APPLICATION OF TEXAS UTILITIES
GENERATING COMPANY, ET AL. FOR
AN OPERATING LICENSE FOR
COMANCHE PEAK STEAM ELECTRIC
STATION UNITS #1 AND #2
(CPSES)Docket Nos. 50-445
and 50-446SURREBUTTAL TESTIMONY OF JACK DOYLE,
WITNESS FOR INTERVENOR CASE

Subject UNIT #1 R.B. S.G. UPPER LATERAL SUPPORT

Title: S.G. UPPER LATERAL RESTRAINT
ACCIDENT TEMP. INVEST.

FIGURE 2

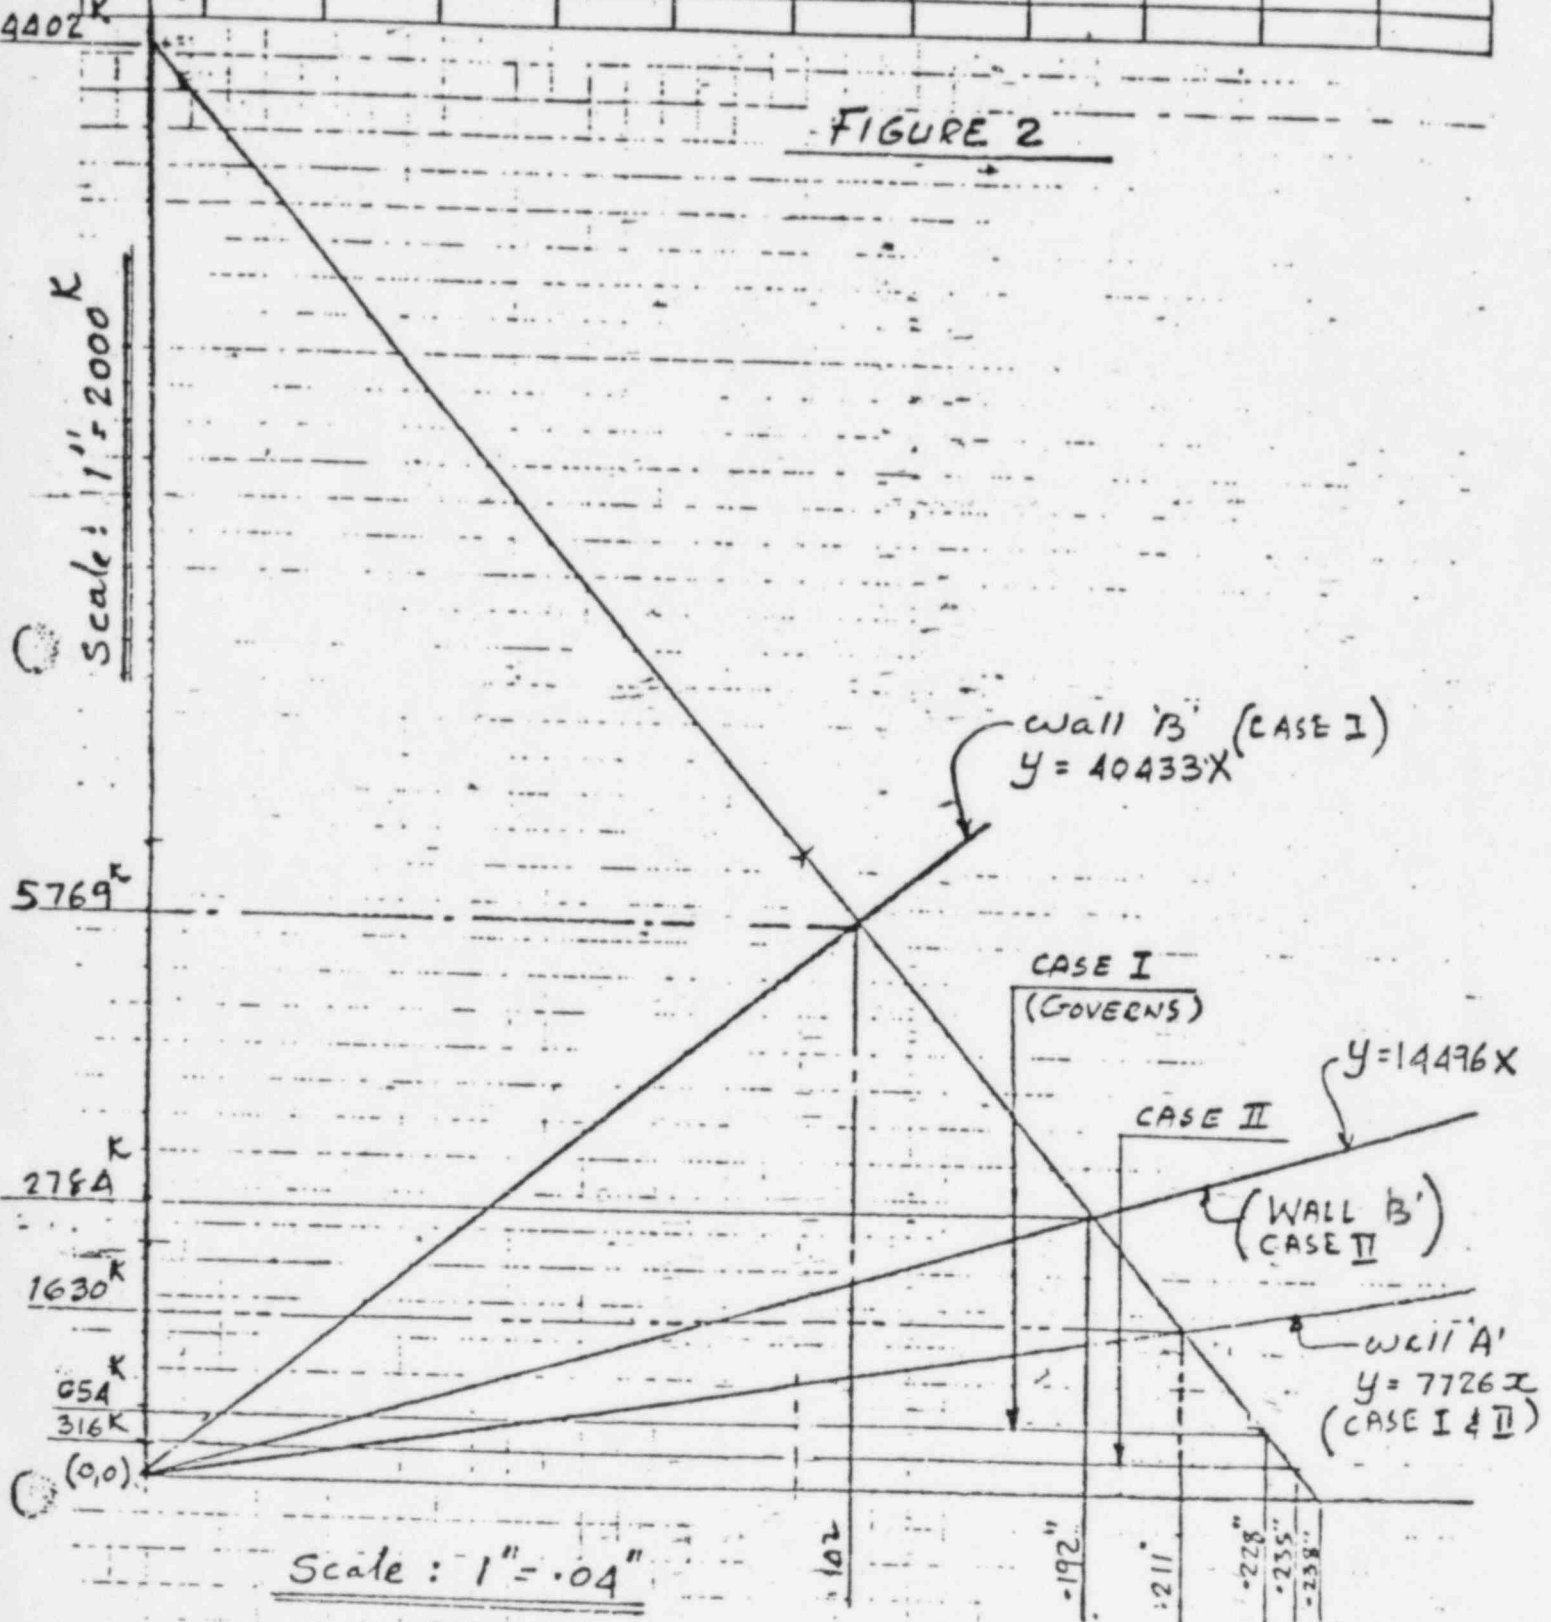
1 equations themselves, I decided to approach the problem independently,
2 using, however, the k factors of the walls, area of the beam, Young's
3 modulus of the concrete, and coefficient of expansion and dimensions
4 indicated in Gibbs and Hill's calculations. The results of approaching
5 the problem from a springs-in-series position results in significant
6 increase in the loads in the beam and on the wall. The hand calculations
7 as shown in CASE Exhibit 761C on the lateral beam were subjected to a
8 computer analysis substituting members of equivalent spring rates to those
9 of the wall.

11 A: The results of the hand calculations supported by the computer
12 analysis indicate a gross error in the fundamental approach as used
13 in the Gibbs and Hill calculations. (See CASE Exhibit 761A for the
14 computer analysis.)

Gibbs & Hill, Inc. Job No. 2323 Client TUSI
 Subject MR SUPPORT STRUCT - ACCIDENT TEMP INVEST.
 Calculation Number SRB-136C SET 6 Sheet No. 169

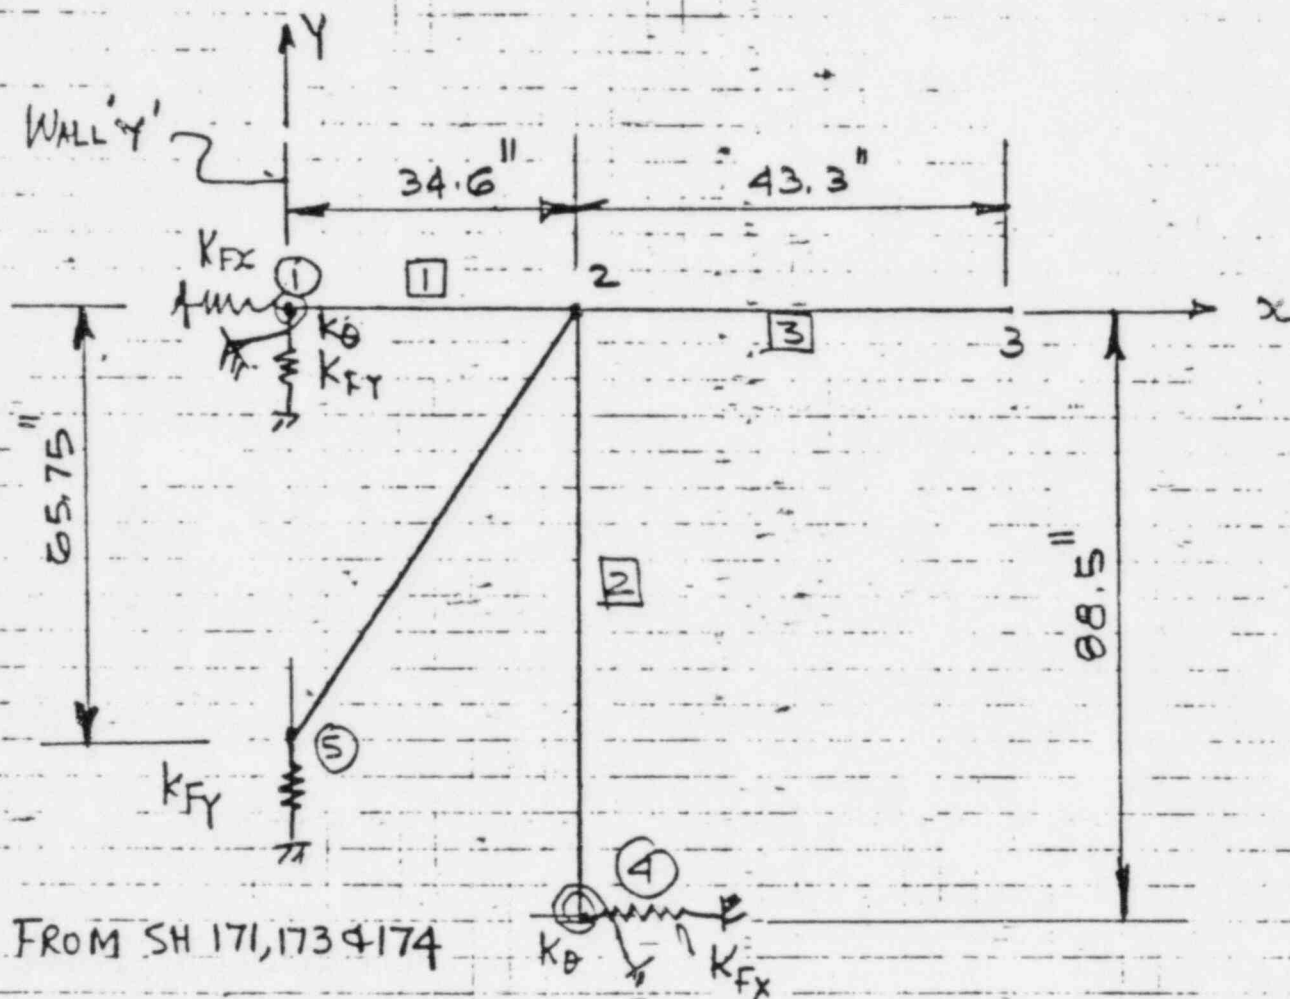
17 A: In the case of the moment restraint structural support, problem
18 45D (CASE Exhibit 761B), in determining the structural stiffness at joints
19 1, 4, and 5, the stiffness of only one anchor bolt was considered. In
20 fact, there are multiple anchor bolts, and of more consequence, shear
21 keys are welded to the base plate which results in k factors several
22 hundred times those used by Gibbs and Hill, who apparently prepared the
23 calculation.

24 These items, the anchor bolts and shear keys, are a parallel spring
25 system. Effectively, these joints will act as rigid connections unless

1 there is a catastrophic failure of the concrete in the area of the
2 shear keys, which will result in unpredictable consequences. For more
3 details regarding this, see CASE Exhibit 761C.

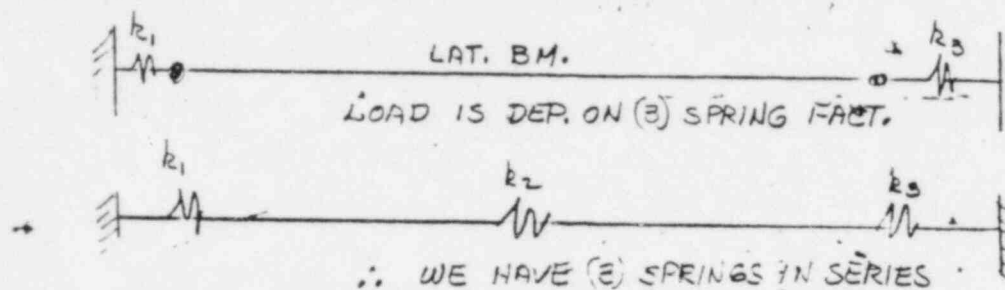
- (2) GIBBS & HILL TREATS THE 280° L.O.C.A TEMP. AS IF IT WERE AN ESTABLISHED FACT.

THE FACT IS THAT THE L.O.C.A. TEMP. PRESSURE PROFILES WERE DEVELOPED TO PRODUCE MAX. PRESSURE TO DESIGN CONTAINMENT. THE ACTUAL L.O.C.A. TEMP COULD BE SIGNIFICANTLY HIGHER THAN 280° . \therefore APPROXIMATING 1 (I.E. .945) FOR INTER ACTION IS COURTING DISASTER.

- (3) ON PAGE 40 GIBBS AND HILL FORGOT TO REDUCE THE F_y BECAUSE OF 300° TEMP.

NO MATTER WHAT ELSE THE BEAM WILL EXPAND $\cdot 238$ OR RELIEF PLUS BM $\Delta = \cdot 238$
